IMPORTANT SAFETY RECALL

NHTSA Safety Recall
No. 21V-337

CSN 821

Unit and Trailer Tie Down Updates

Figure 7 – Load Trail Revision A Trailer

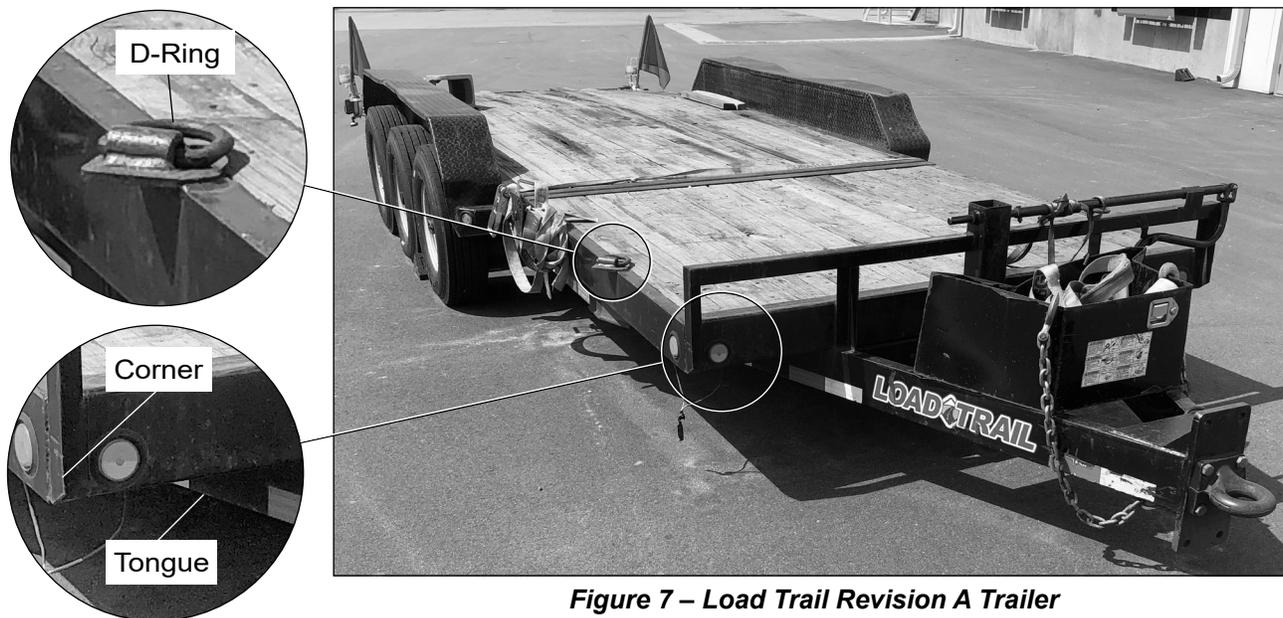
1. On a Revision A trailer, the angled tongue frame rails are inset from the front corners of the stationary cargo deck and the D-ring mounting plates overhang beyond the outboard side of the cargo deck frame rails (refer to Figure 7). This type of trailer requires the D-Rings Kit for Load Trail Trailer Revision A, part number 991342027.

Figure 8 – Load Trail Revision B Trailer Without Side Flanges

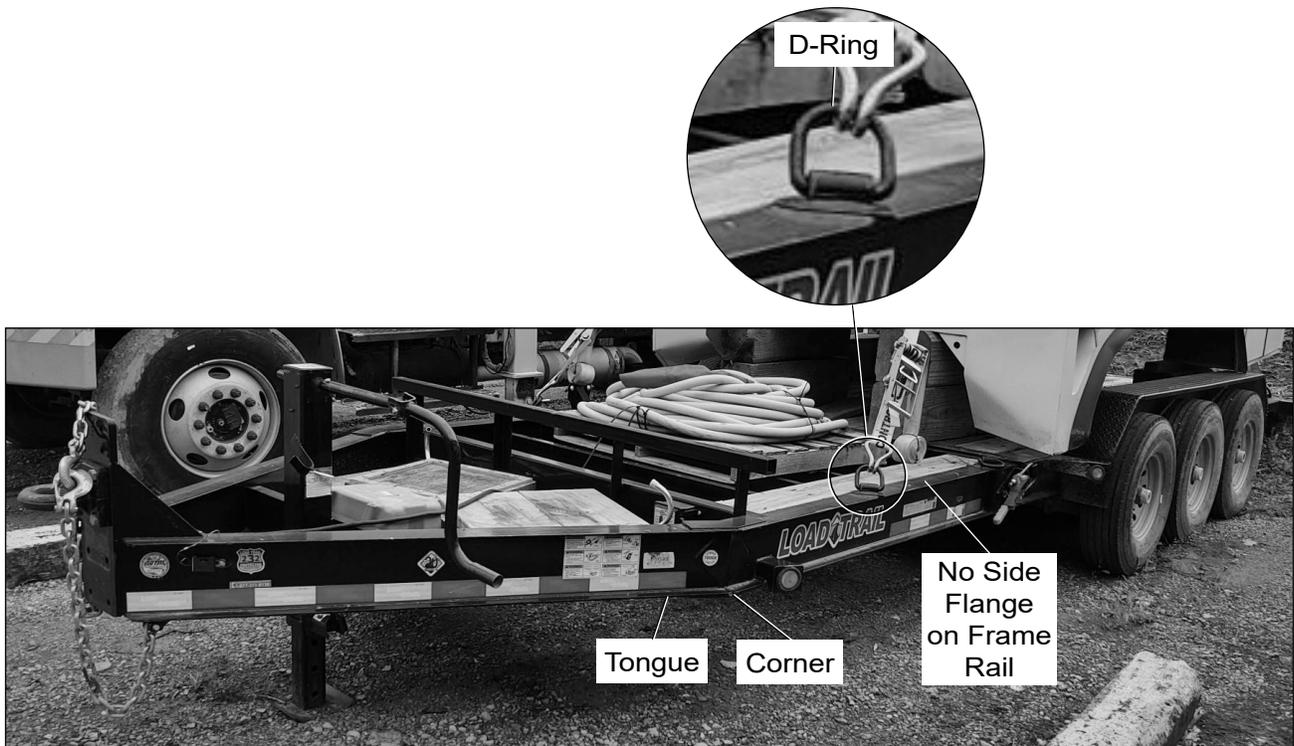
2. On a Revision B trailer without side flanges, the angled tongue frame rails connect at the corners of the stationary cargo deck and the D-ring mounting plates are centered on the top plate width of the cargo deck frame rails which do not have side flanges installed on them (refer to Figure 8). This type of trailer requires the D-Rings Kit for Load Trail Trailer Revision B Without Side Flanges, part number 991346931.

Figure 9 – Load Trail Revision B Trailer With Side Flanges

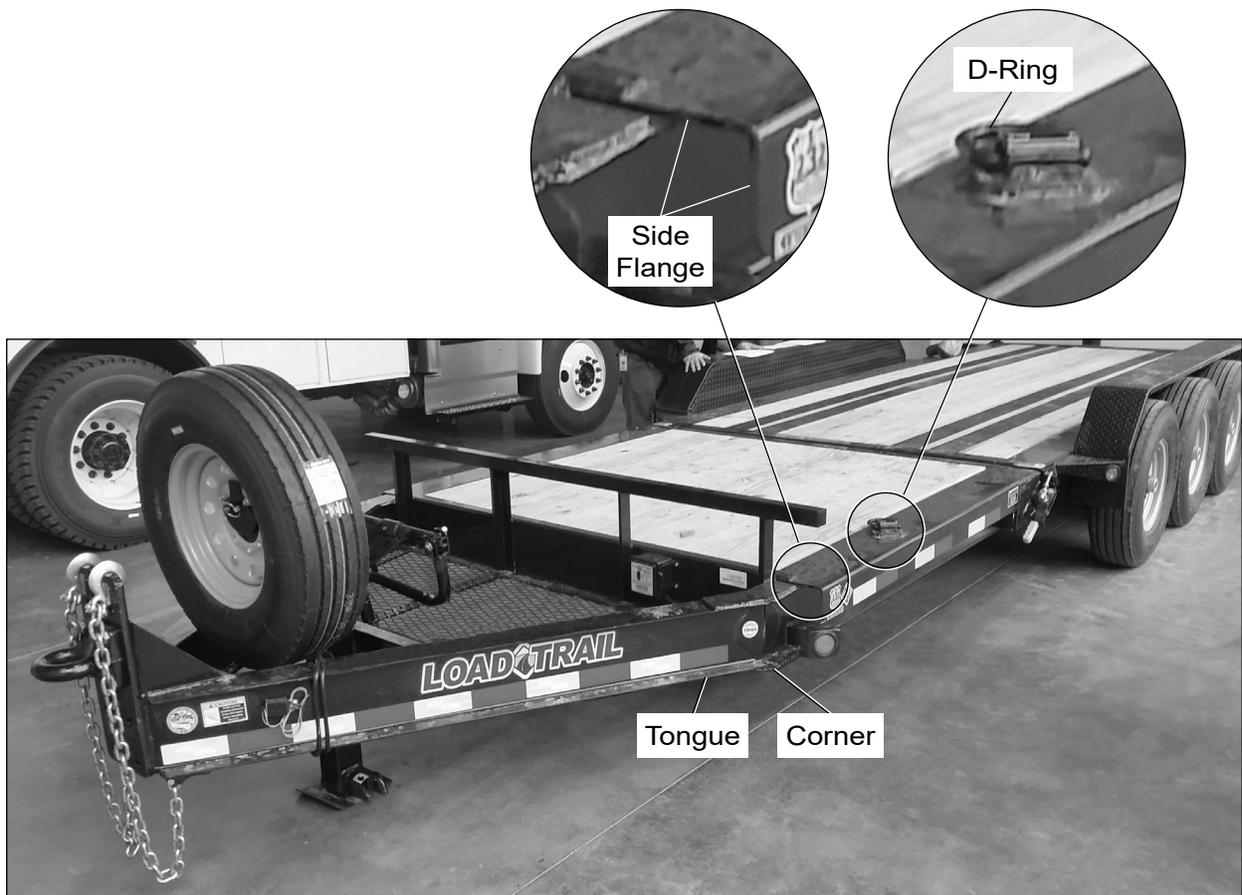
2. On a Revision B trailer with side flanges, the angled tongue frame rails connect at the corners of the stationary cargo deck and the D-ring mounting plates are centered on top of side flanges that are installed over the top plates of the cargo deck frame rails (refer to Figure 9). This type of trailer requires the D-Rings Kit for Load Trail Trailer Revision B With Side Flanges, part number 991342028.

Figure 11 – Correct Hook Engagement

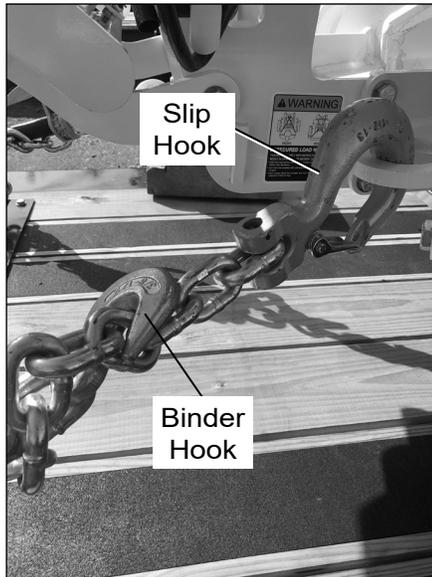
6. When installing the chains to secure the unit to the trailer for transport, the grab hooks on the chain binder must not be allowed to contact the slip hooks (hooks with spring-loaded latches) on the tie down chains (refer to Figures 11 and 12). Improper link contact is likely to happen when the binder hook is connected to the second link from the slip hook. The chain installation requirement is stated in an insert that will be added to the Operator's and Maintenance Manuals and on new Warning placards that will be added to the trailer as part of the tie down system updates.
